**SUBJECT:** ELECTRICAL POWER - REMOVAL OF REVERSE CURRENT DIODE FROM ALTERNATOR SYSTEM

BEECHCRAFT Skipper 77, serials WA-1 through WA-312.

**Issued: June, 1987**

**Revised: December, 1987**

Figure 1

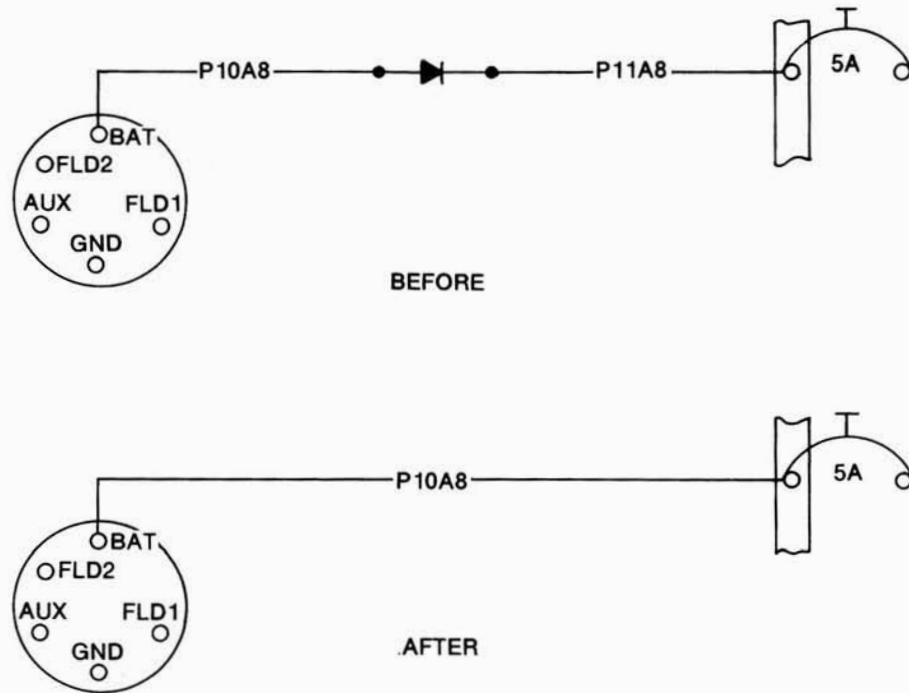
Beech Aircraft Corporation is issuing this Service Bulletin to reduce the possibility of the subject diode overheating and causing smoke in the cockpit. Subsequent review reveals the diode to be unnecessary, therefore, it should be removed from the electrical circuit on all affected airplanes.

Changed Step 4 to reflect 8 gage wire which conforms to P/N MIL-W-22759/16 or MIL-W-5086.

1. Turn off and disconnect all electrical power and disconnect the battery.
2. Gain access to the alternator reverse current diode which is located on the forward side of the Power Control Quadrant Panel.
3. Remove and discard the reverse current diode.
4. Cut a piece of 8 gage wire which conforms to MIL-W-22759/16 or MIL-W-5086, approximately 70 inches long.
5. Attach terminals to the ends of the wire as follows:
  - a. Attach either a P/N 330968 or P/N 332042 terminal (P/N's of AMP Inc., Harrisburg, PA) to the alternator terminal of the wire.
  - b. Attach a P/N 322047 terminal to the bus bar end of the wire.
6. Permanently mark the wire "P10A8" within three inches of both ends.
7. Refer to the illustration and replace existing wires P10A8 and P11A8 with the wire fabricated in Steps 4 through 6.
8. Restore electrical power to the airplane.
